U.S. Department of the Interior
BUREAU OF LAND MANAGEMENT

Sundry ID: 2668159

Type of Action: Plug and Abandonment

P&A Procedure**EPIC Energy – Escrito Gallup Unit #27**

Escrito Gallup Unit #27**Proposed P&A****Escrito Gallup Unit**

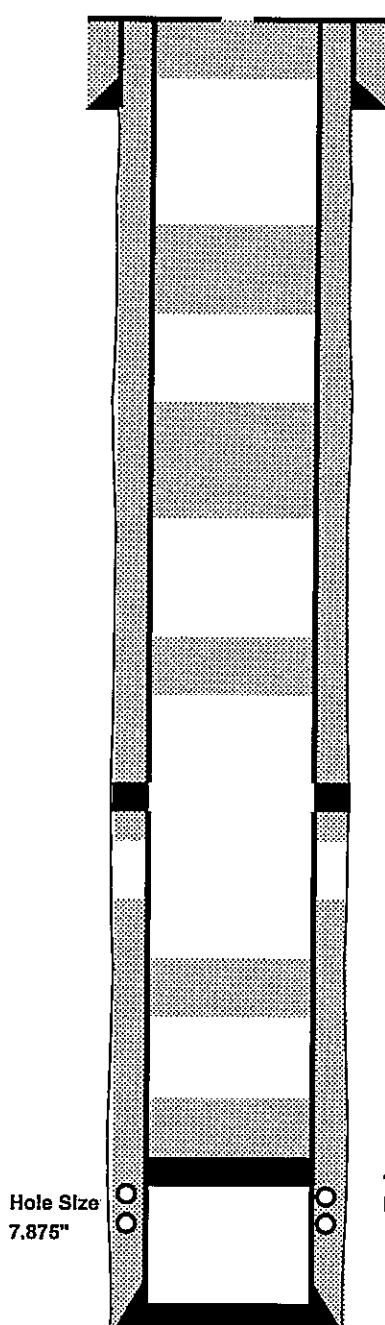
1. Plugging operations authorized are subject to the attached "General Requirements for Permanent Abandonment of Wells on Federal and Indian Lease."
2. The following modifications to your plugging program are to be made:
 - a. Add an inside/outside plug to cover the Chacra formation top at 2824'.
 - b. Add a plug, or modify a planned plug, to cover minimum 50 feet below and above the surface casing shoe at 219'.
3. Farmington Office is to be notified at least 24 hours before the plugging operations commence (505) 564-7750.

- Add an inside/outside plug to cover the Chacra formation top at 2824'.

You are also required to place cement excesses per 4.2 and 4.4 of the attached General Requirements.
